ADDENDUM NO. 1

TERRY CARGIL RESERVOIR

LACEY CONTRACT NO. PW 2019-32

E-4

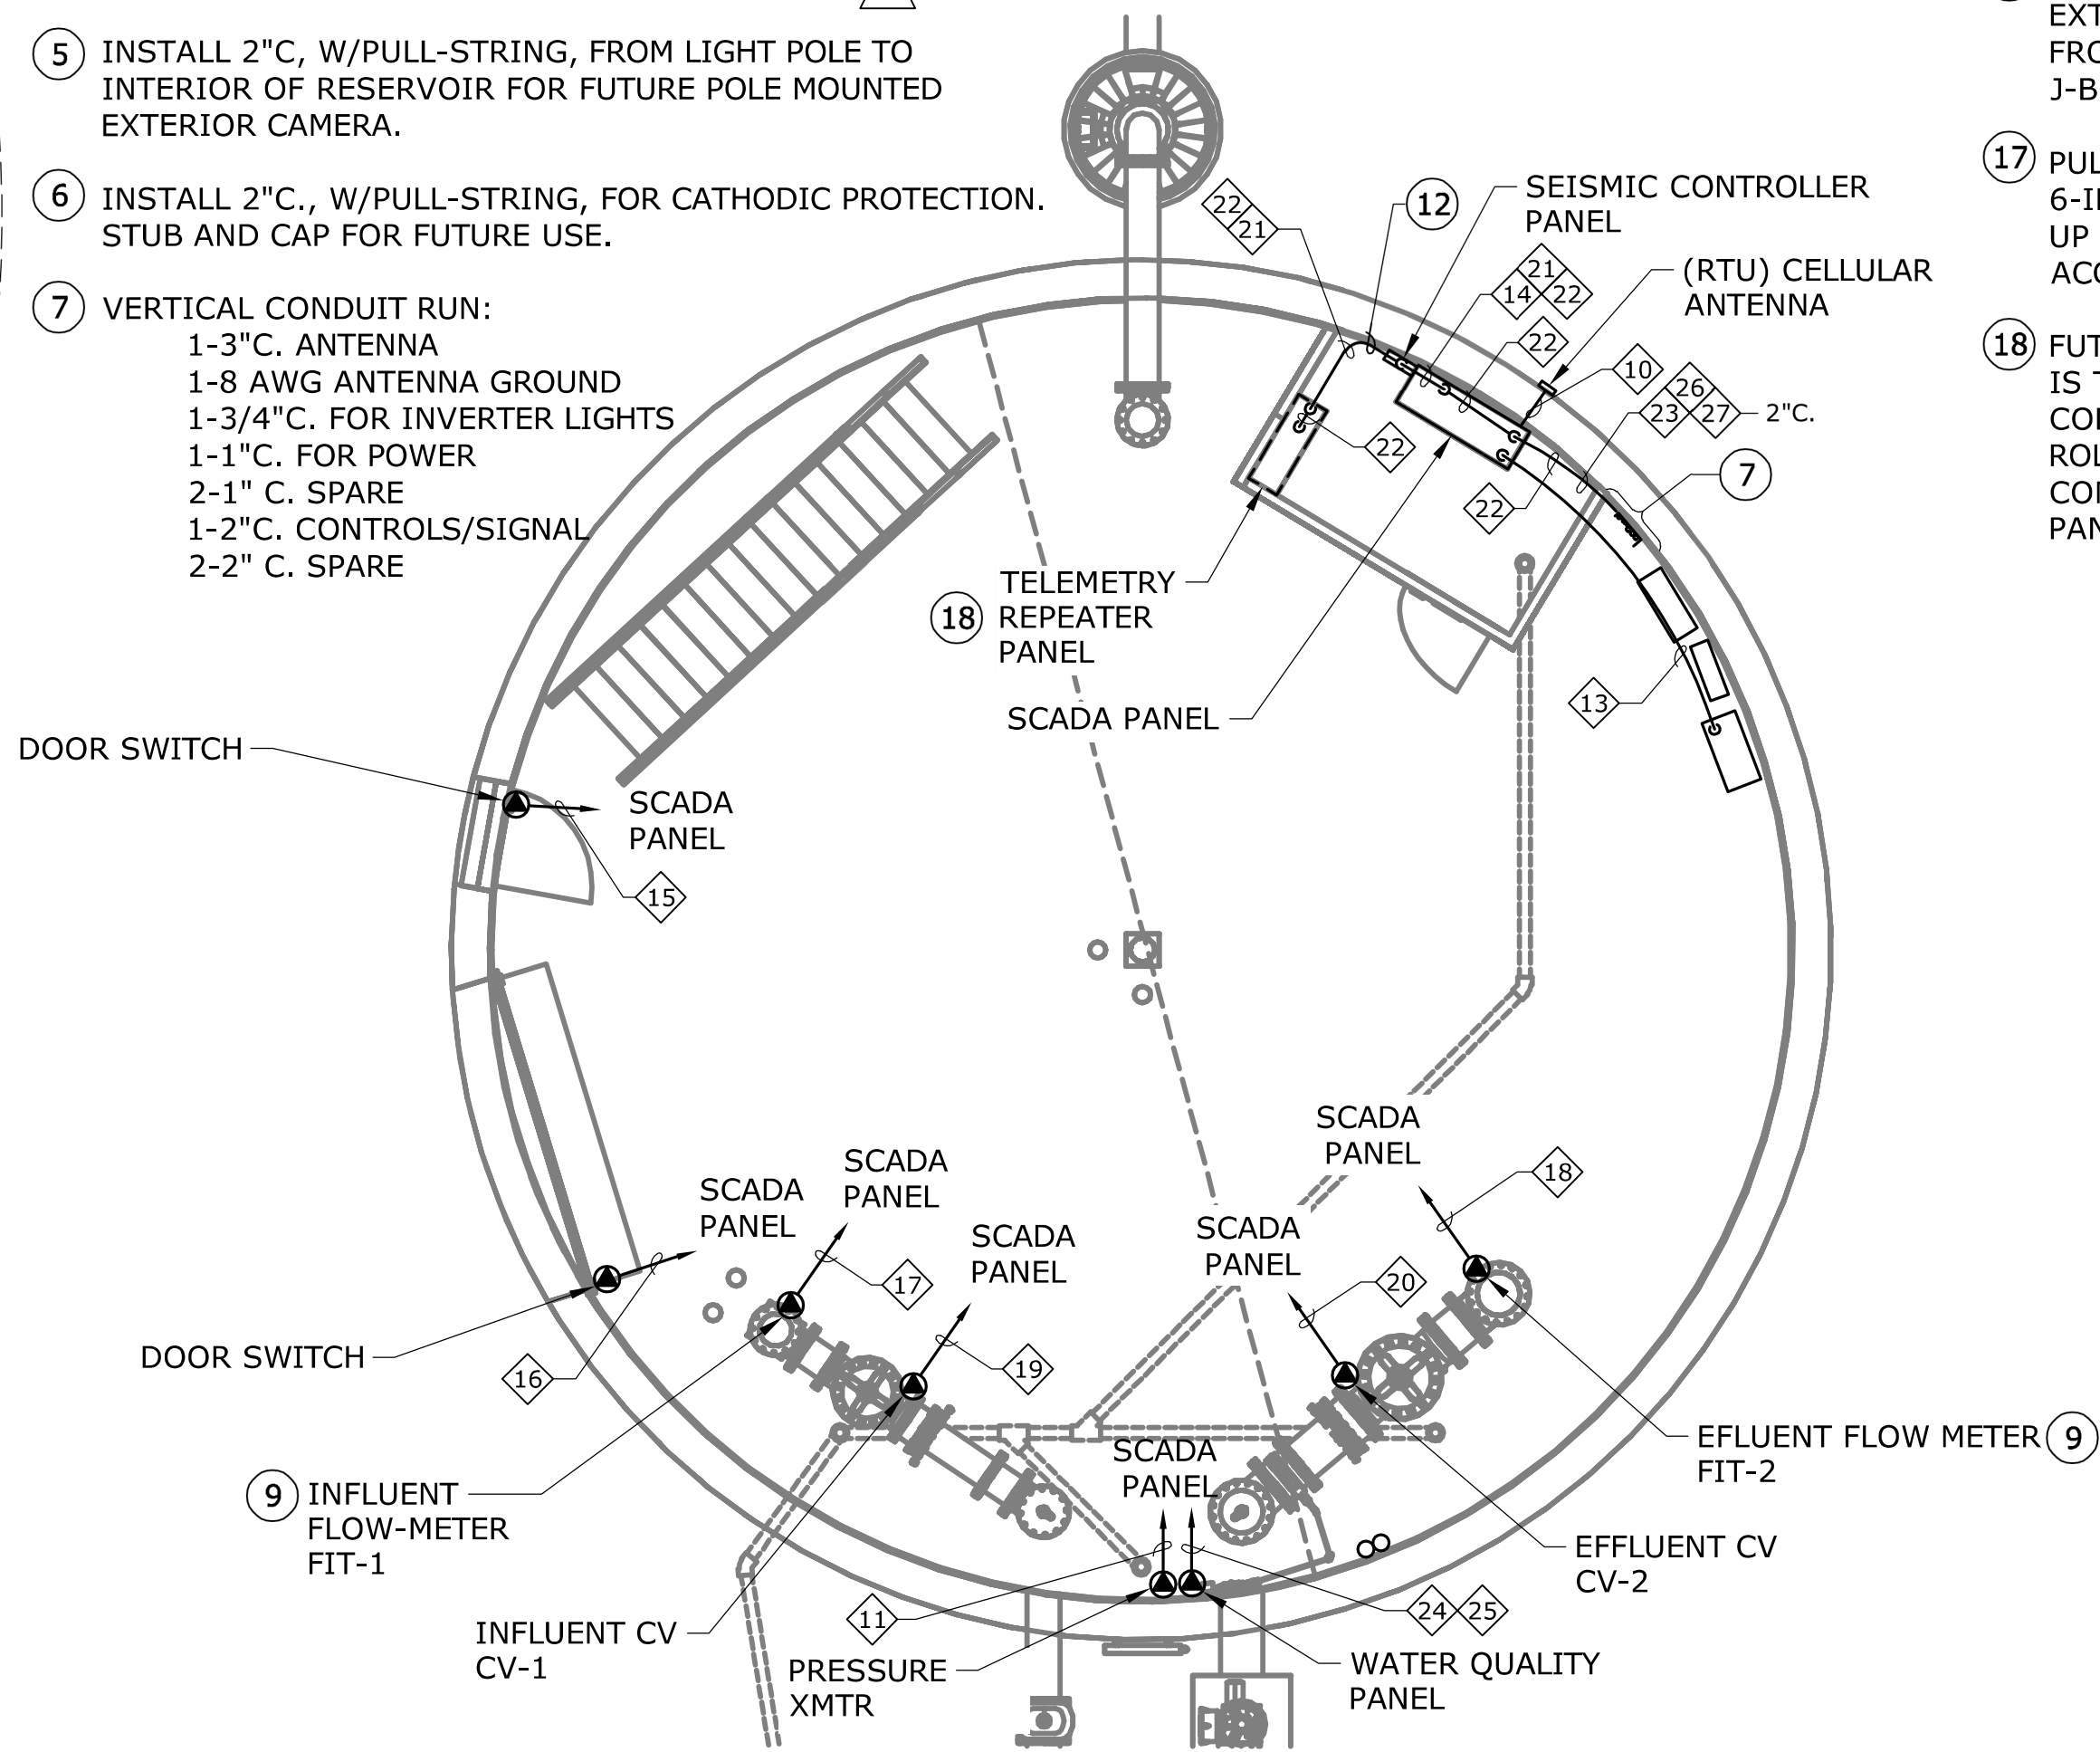
- 1) *The revisions include changes to notes related to the 6-inch diameter spare conduits.*
Delete Sheet E-4 / Page 50 of 62 and replace it with the new page as attached.

1. ALTERNATE OPTION: CONTRACTOR MAY INSTALL (4) 4-IN "SPARE" CONDUITS IN LIEU OF THE (2) 6-IN "SPARE" CONDUITS CALLED OUT IN KEYED NOTES 4 AND 17. MAKE SIZE ADJUSTMENTS TO PULL BOX(ES) AS REQUIRED. FOR PULL BOX(ES) IN VERTICAL RUN, PER KEYED NOTE 17, CONTRACTOR MAY USE ONE PULL BOX AND TERMINATE ALL FOUR 4-IN CONDUITS IN BOX, USE TWO PULL BOXES AND TERMINATE (2) 4-IN CONDUITS PER BOX, OR USE FOUR INDIVIDUAL PULL BOXES. CONTRACTOR MAY USE WIREWAYS AS PULL BOXES. PULL BOX(ES) TO BE SIZED PER NEC 314.28. SEE ALSO SHEET E-13.

SHEET
E-7
53 of 62

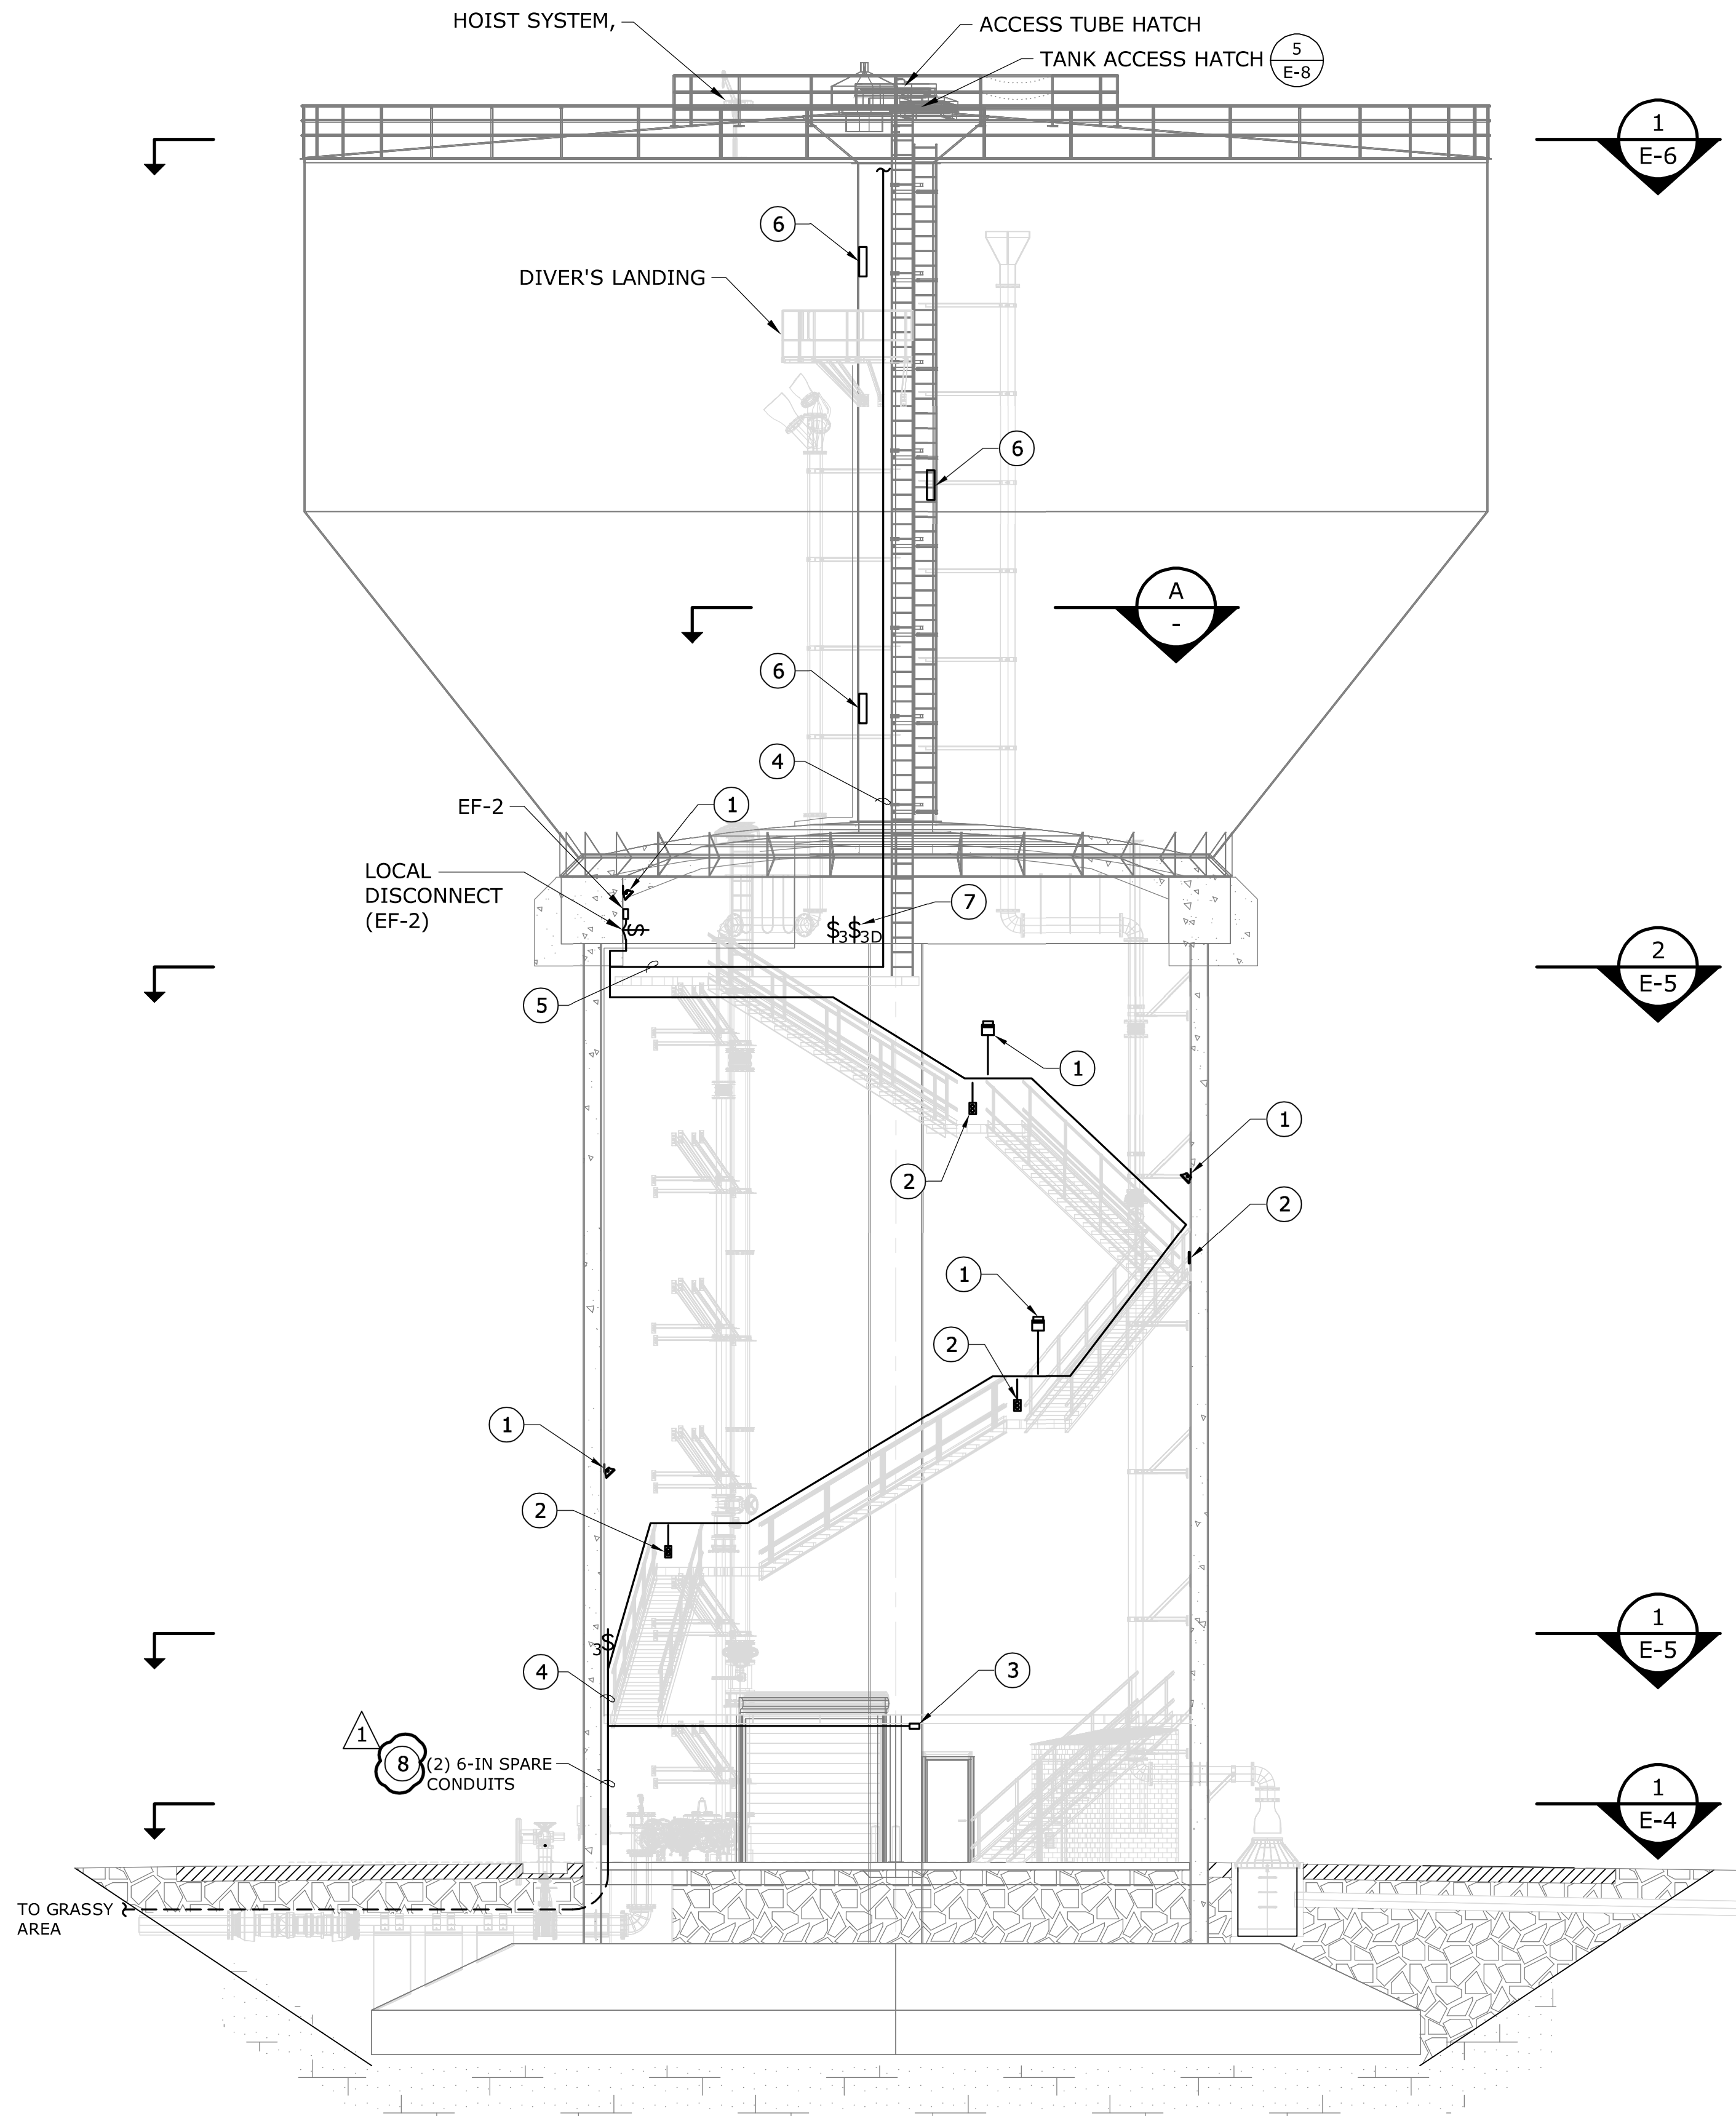
- 1) *The revisions include changes to notes related to the 6-inch diameter spare conduits.*
Delete Sheet E-7 / Page 53 of 62 and replace it with the new page as attached.

- ⑧ ALTERNATE OPTION: CONTRACTOR MAY INSTALL (4) 4-IN "SPARE" CONDUITS IN LIEU OF THE (2) 6-IN "SPARE" CONDUITS. SEE SHEET E-13
